## **Access Compliance Report Public Rights-of-Way** (Curb Ramps)

Intersection ID: 52590 Main Street: NOBLES AV Cross Street: TRIUMPH\_DR Location: NE ADA ID: C47111C993C8 Ramp Type: Perp Initial Pass/Fail: Fail **Overall Compliance: No Severity Score:** 12.5

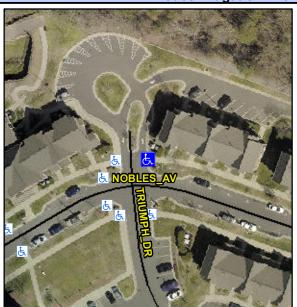
Possible Solutions: Remove & Replace Entire Ramp. Surveyor Notes: N/A PROW/ADA: Not Found, R304.2.2

Field Measurements/Component Compliance					
Compliance Description		Data	Comp	liance Description	Data
N/A	Ramp Length (in)	62.0	No	Ramp Slope (%)	9.1
Yes	Ramp Width (in)	72.0	Yes	Ramp XSlope (%)	0.7
N/A	Flare Type LT	N/A	N/A	Flare Type RT	N/A
N/A	Flare Slope LT (%)	N/A	N/A	Flare Slope RT (%)	N/A
N/A	Flare Traversable LT?	N/A	N/A	Flare Traversable RT?	N/A
N/A	Landing Length (in)	N/A	N/A	DWS Provided?	N/A
N/A	Landing Width (in)	N/A	N/A	DWS Contrast?	N/A
N/A	Landing Slope (%)	N/A	N/A	DWS Length (in)	N/A
N/A	Landing X Slope (%)	N/A	N/A	DWS Full Width?	N/A
N/A	Landing Curb? (Y/N)	N/A	N/A	DWS Offset (in)	N/A
N/A	Shared Landing?	N/A			
N/A	Gutter Ponding?	N/A	N/A	Gutter Slope (%)	N/A
N/A	Gutter Lip Ht (in)	N/A	N/A	Gutter X Slope (%)	N/A
N/A	Painted X Walk1?	No	N/A	Painted X Walk2?	N/A
	X Walk 1 Direction	To W		X Walk 2 Direction	N/A
N/A	X Walk 1 Width (in)	N/A	N/A	X Walk 2 Width (in)	N/A
	X Walk 1 Slope (%)	0.4		X Walk 2 Slope (%)	N/A
